Access Compliance Report Public Rights-of-Way (Curb Ramps)

Main Street: 17TH_ST Cross Street: HEWES_AVE Location: NW

ADA ID: RPRK211008122259 Ramp Type: Type 1 - Perpendicular Diagonal Initial Pass/Fail: Pass Overall Compliance: No Severity Score: 2

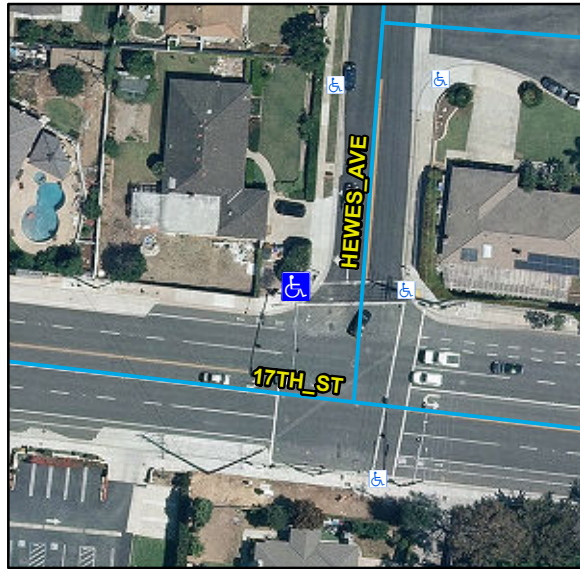
R304.2.2, R304.2.2-Perp, R304.3.2-Para, R304.5.3, STD 1115

Remove & Replace Curb Ramp With Two New Directional Ramps or Equivalent. Remove & Replace Gutter.
